Callaway Plant

ULNRC-05929

**DOCKET NUMBER 50-483  
CALLAWAY PLANT UNIT 1  
UNION ELECTRIC CO.  
FACILITY OPERATING LICENSE NPF-30  
RESPONSES TO RAI SET #16 AND AMENDMENT 16 TO THE CALLAWAY LRA**

REQUEST FOR ADDITIONAL INFORMATION (RAI) Set #16 RESPONSES

FIGURE 1

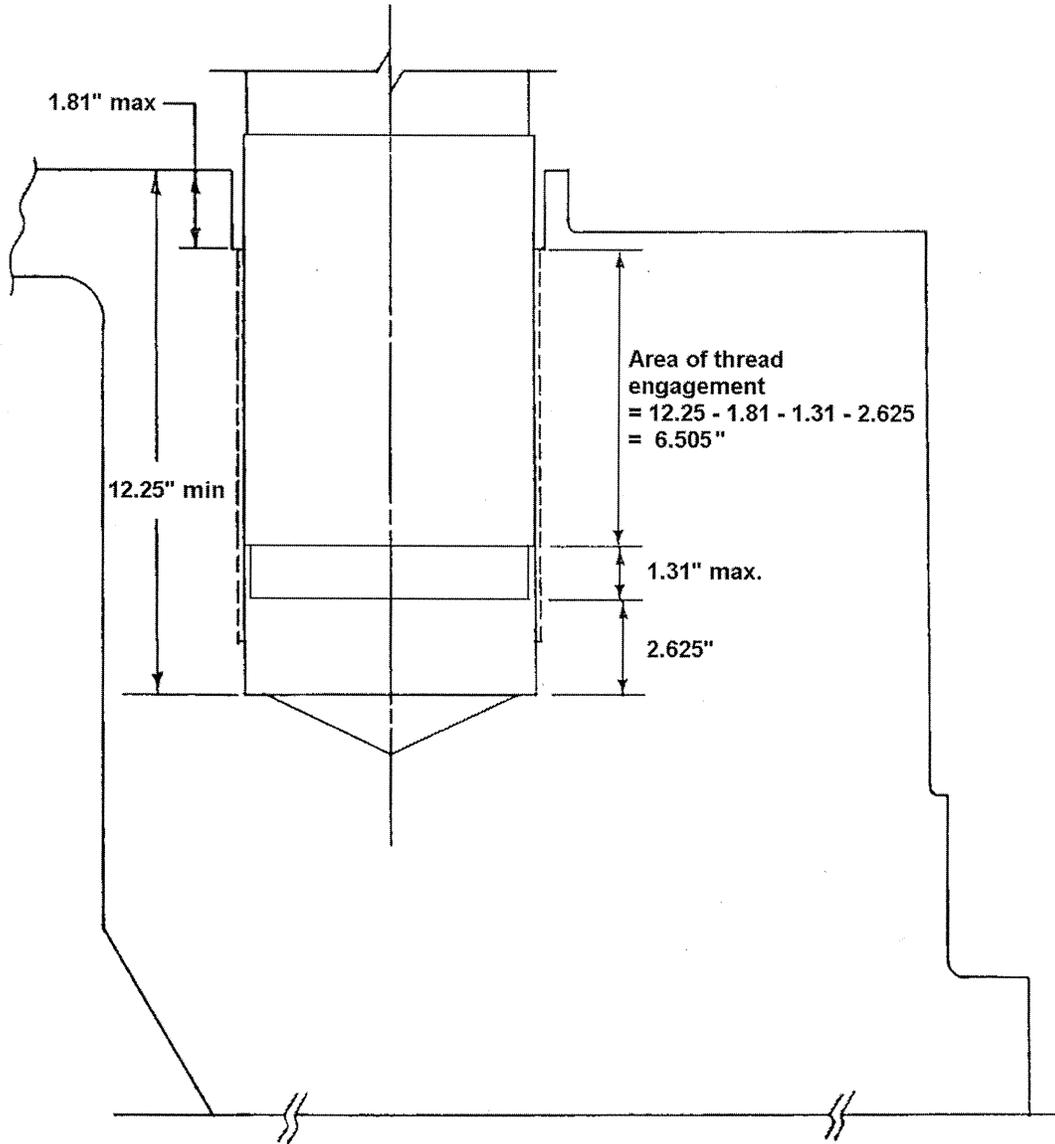
The staff needs clarification of the applicant's basis for stating that the stuck stud has 6.505 inches of thread engagement remaining and that the required minimum thread engagement is 6.31 inches.

Provide the basis for determining that all of the engaged threads for stud No. 18 are undamaged. In addition, provide justification of the evaluations used to support the basis that stud No. 18 has 6.505 inches of thread engagement, and that the required minimum thread engagement is 6.31 inches.

The length of thread engagement for stud 18 is calculated as follows. A sketch (Figure 1) follows this RAI response. The depth of the stud hole is a minimum of 12.25 inches. The distance from the top of the stud hole to the top of the threads in the stud hole is a maximum of 1.81 inches. The distance from the bottom of the stud hole to the bottom of the stuck stud is 2.625 inches. The distance from the bottom of the stuck stud to the bottom of the threads on the stuck stud is a maximum of 1.31 inches. Thus, the length of thread engagement is  $12.25 - 1.81 - 2.625 - 1.31 = 6.505$  inches.

The value of 6.31 inches for minimum length of thread engagement is obtained from information in Combustion Engineering report CENC-1509, *Addendum 2 to Analytical Report for Union Electric Company Callaway Nuclear Power Plant Unit No. 1 Reactor Vessel*. From this report, with full thread engagement length of 9.24 inches, the applied shear stress for the vessel threads is 10.94 ksi. The allowable vessel shear stress is 16.02 ksi. The minimum allowable thread engagement length is then calculated as

$9.24 \times 10.94/16.02 = 6.31$  inches.
